Addendum No. 1
Rock River Water Reclamation District
Plant Roadway Replacement 2019
Capital Project No. 2006

This Addendum Number 1, dated May 6, 2019, for the above referenced project, supersedes all contrary and conflicting information in the specifications and contract documents, which are hereby supplemented or revised as follows:

PLANT ROADWAY REPLACEMENT 2019

CAPITAL PROJECT #2006

| Item No. | Quantity | Unit | Description | Unit Price (In Writing) | Unit Price (In Figures) | Total Price (In Figures) |

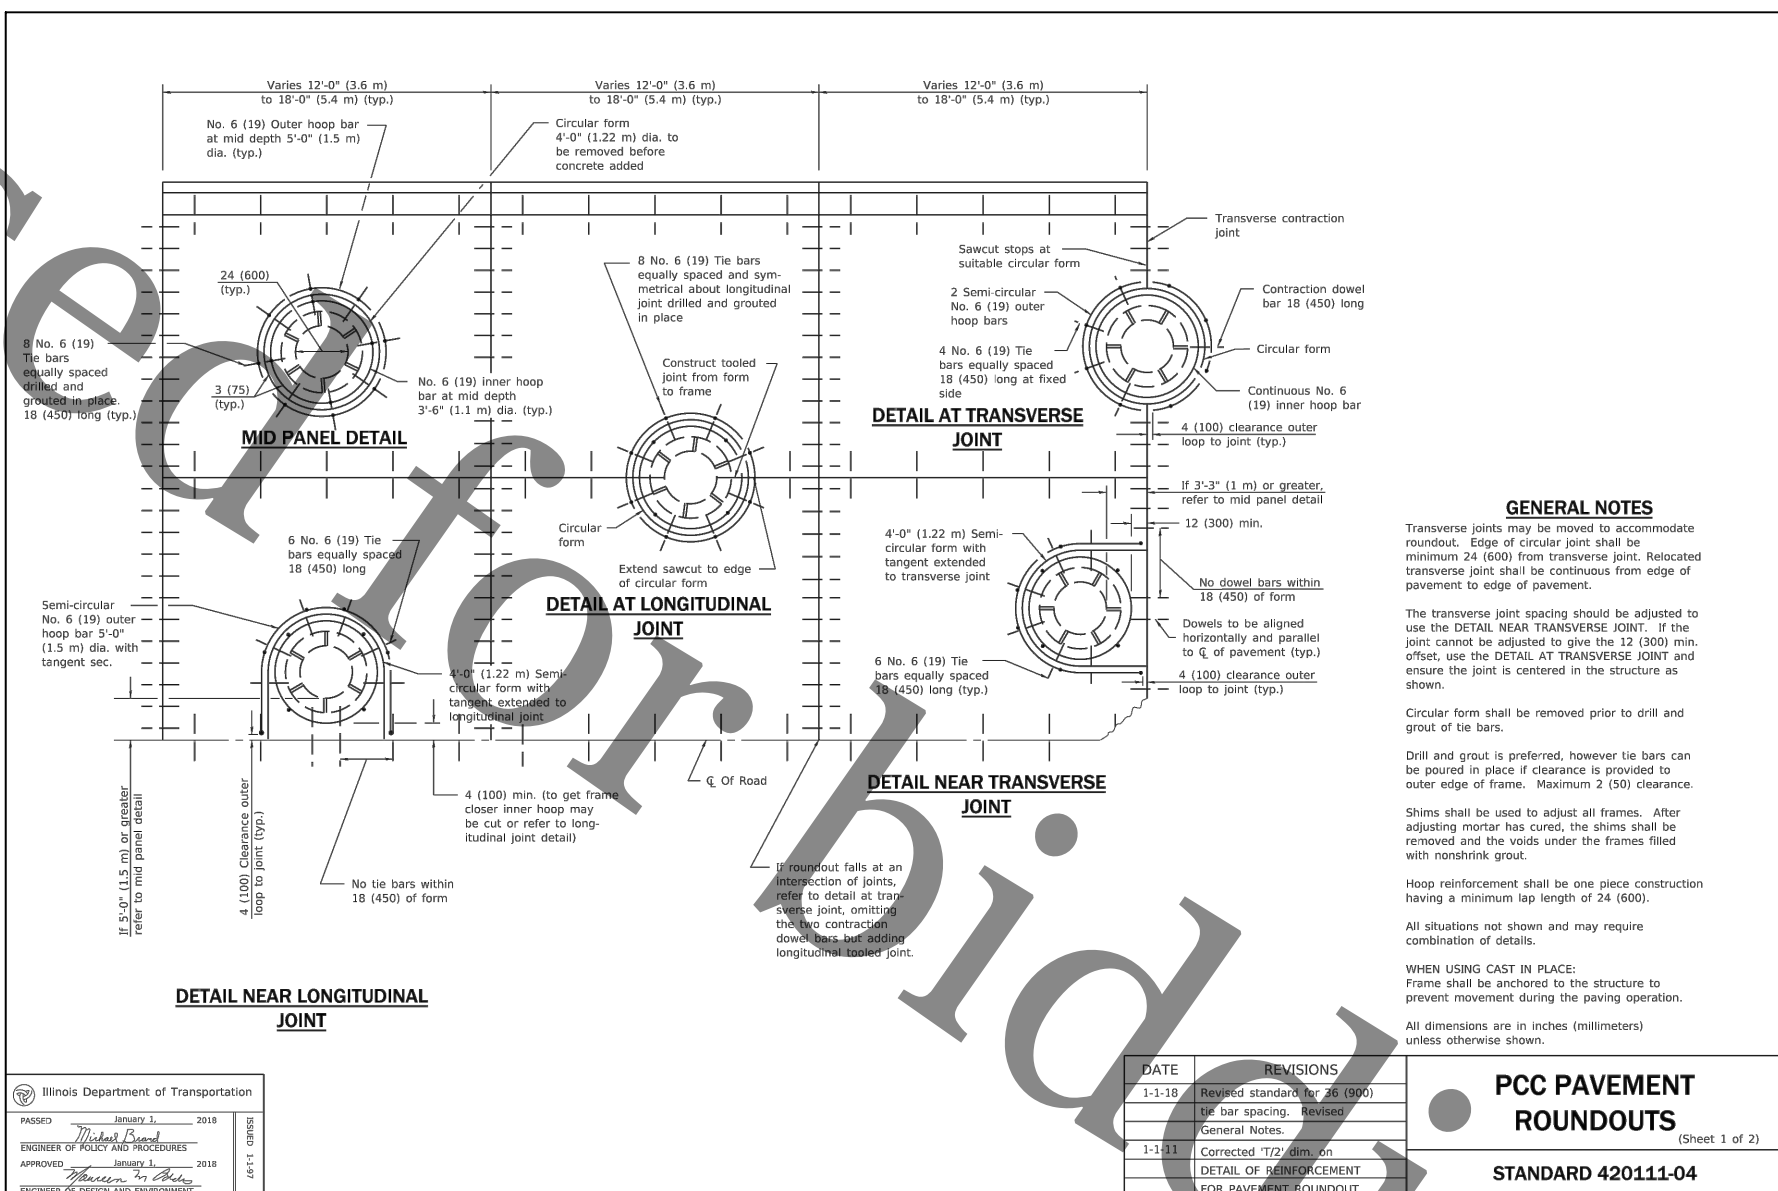
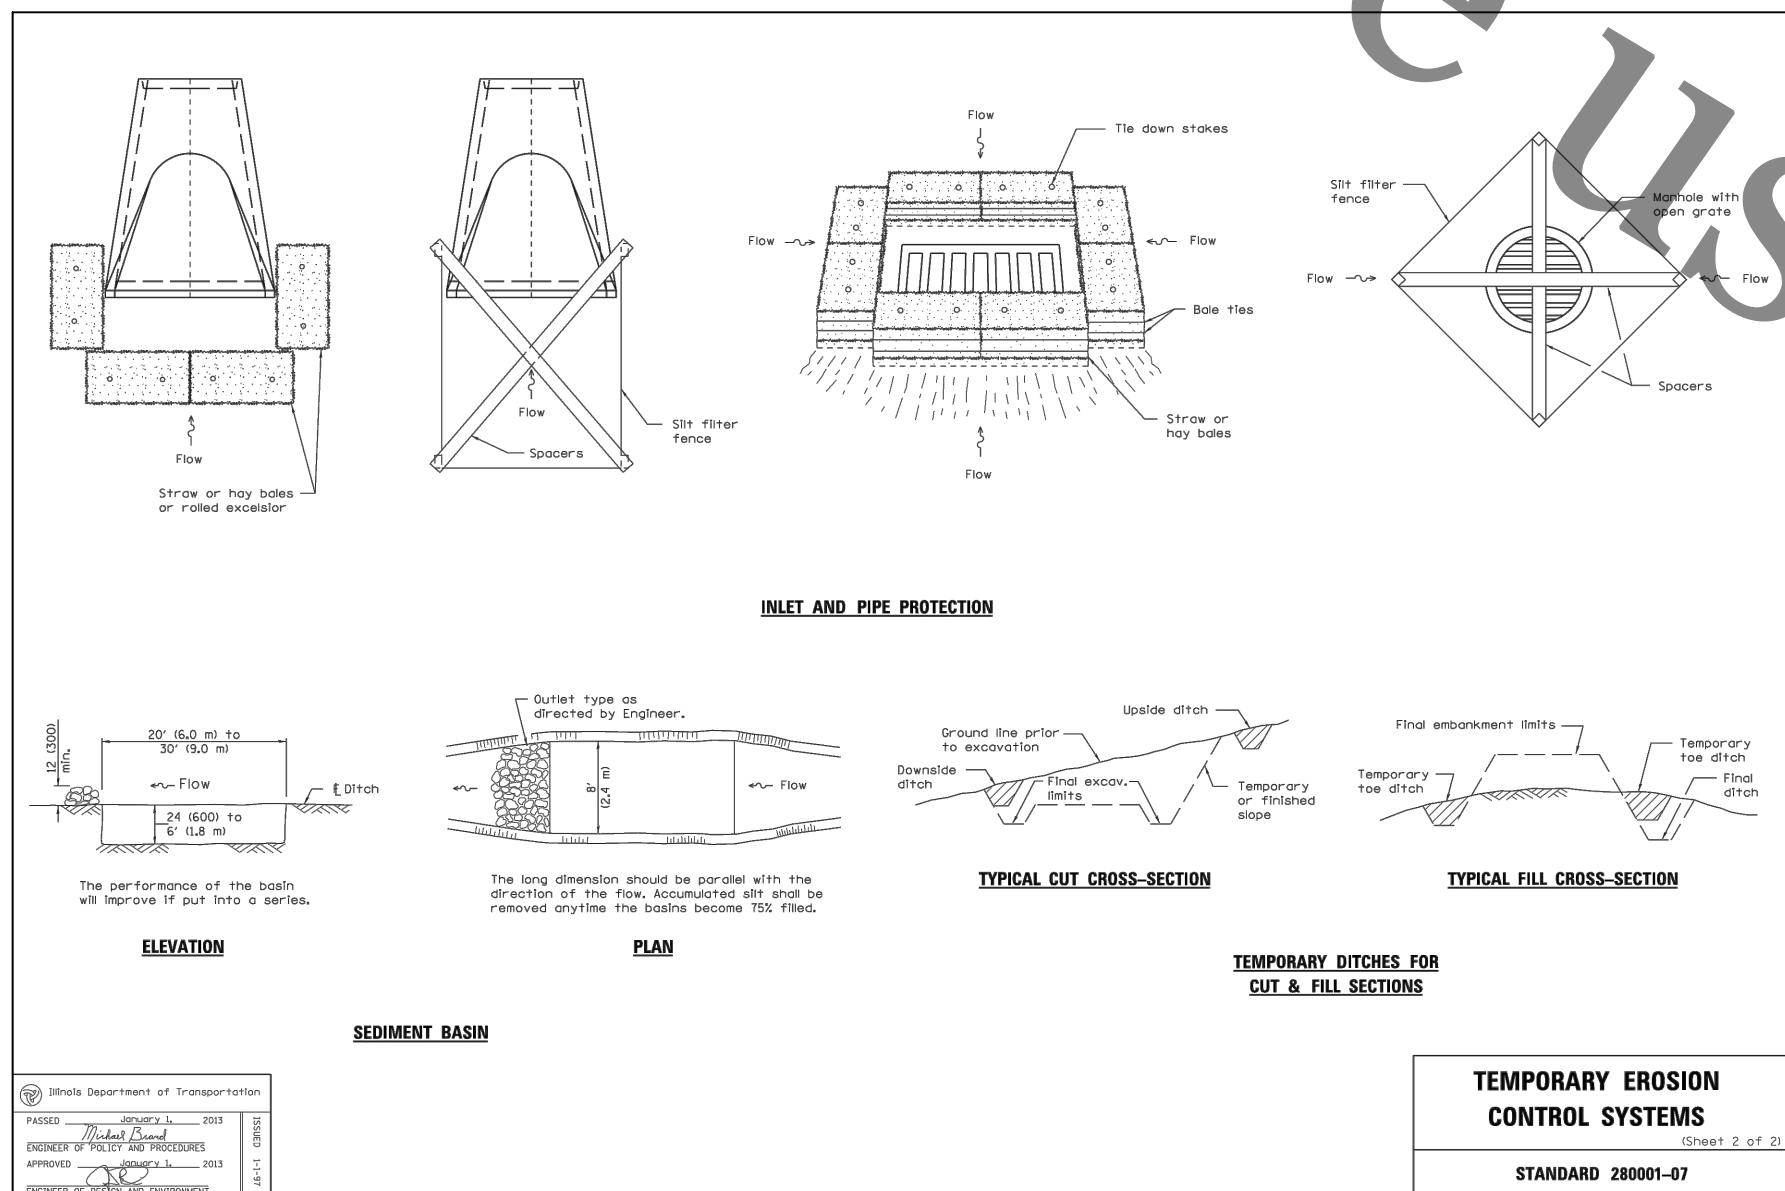
Sheet 4 of 12: EXISTING CONDITIONS & REMOVALS

1. Plan view has been updated to reflect the existing light pole foundation located at STA 101+97, 3' LT shall be abandoned in place. District staff will remove the light pole prior to construction.

| No. | DATE | REVISION | INT. |
|-----|--------|--|------|
| 1 | 5/6/19 | ADDED NOTE LIGHT POLE TO BE REM PRIOR TO CONST. @ 102+00 3' LT PER AD. #1. | KG |

Sheet No.
11 OF 12

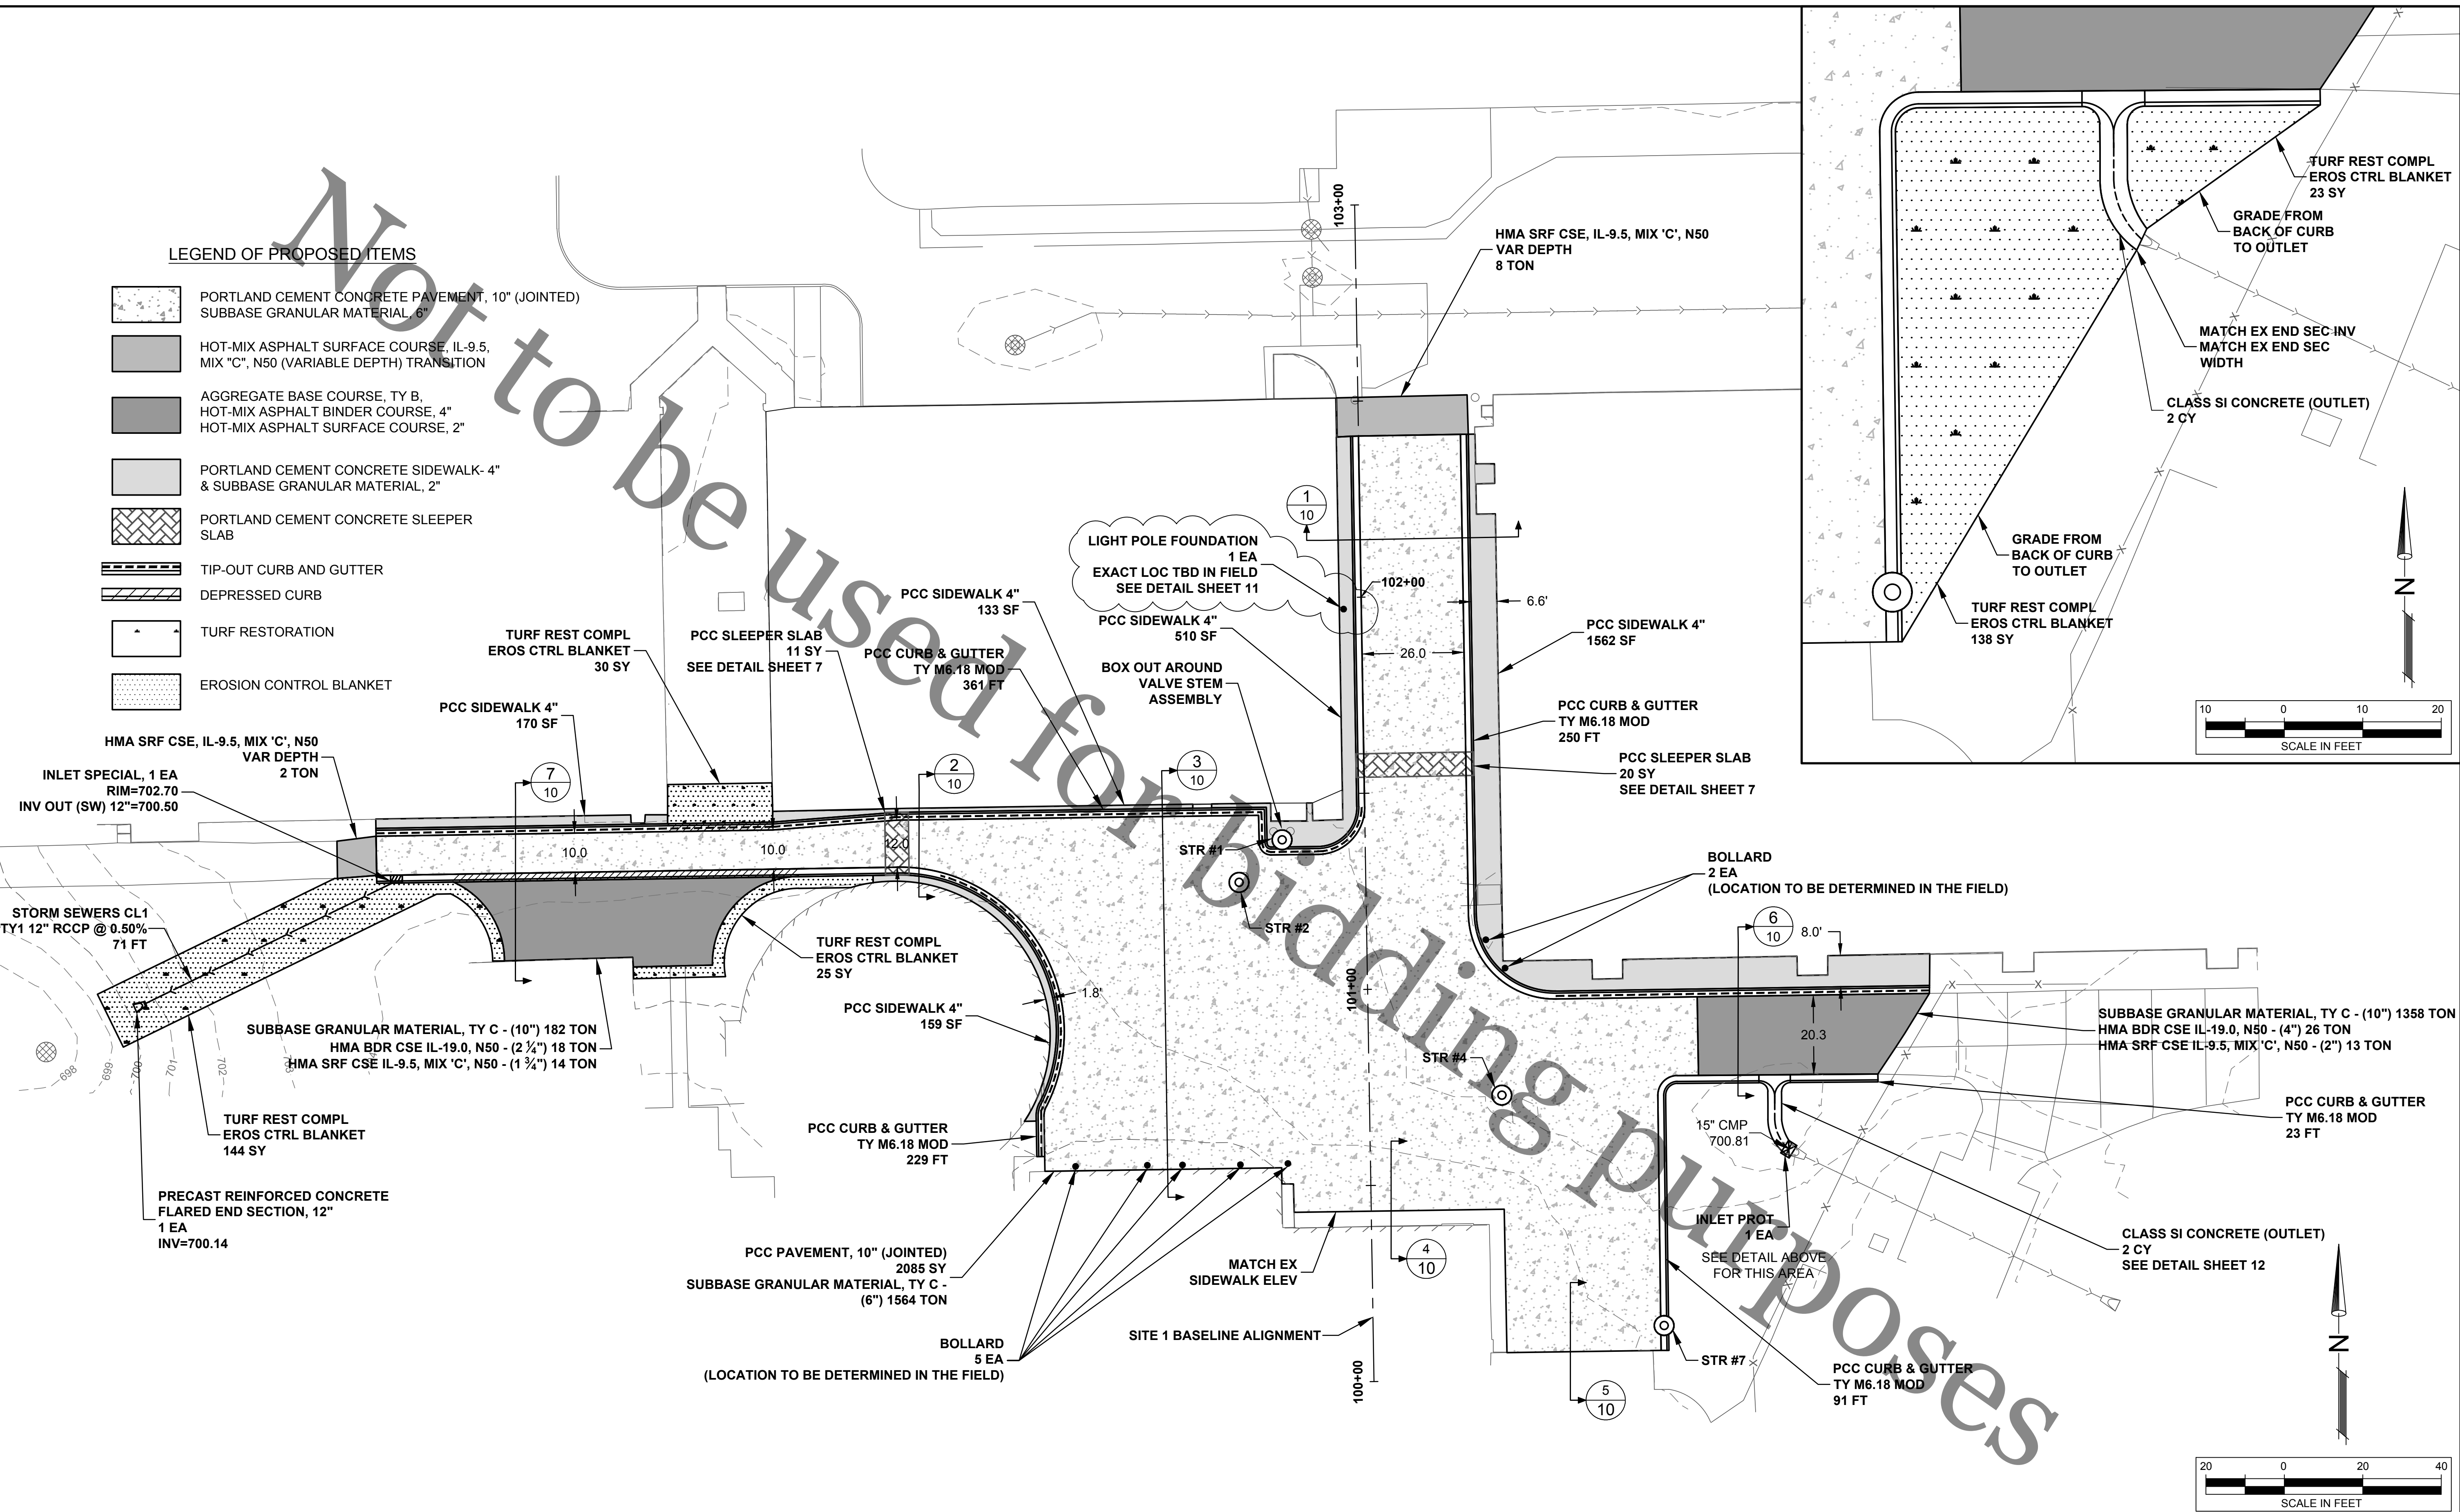
Sheet 11 of 12: PROJECT DETAILS

1. Detail has been added for the LIGHT POLE FOUNDATION pay item.

| No. | DATE | REVISION | INT. |
|-----|--------|---------------------------------------|------|
| 1 | 5/6/19 | ADDED DETAIL 'LIGHT POLE FOUNDATION'. | KG |

33 Light Pole Foundation

This work shall conform to Section 836 of the *IDOT Standard Specifications*. The foundation shall be a drilled shaft cast-in-place Portland Cement Concrete foundation in accordance with the details shown on the Plans.

Anchor bolts shall be 1" diameter with an embedment depth of not less than 36" within the foundation.

Portland Cement Concrete shall be Class SI mix per Article 1020.04 of the *IDOT Standard Specifications*.

Anchor bolts shall be Grade 105 (Grade 725) full length galvanized with washers and nuts in accordance with Article 1006.09 of the *IDOT Standard Specifications*.
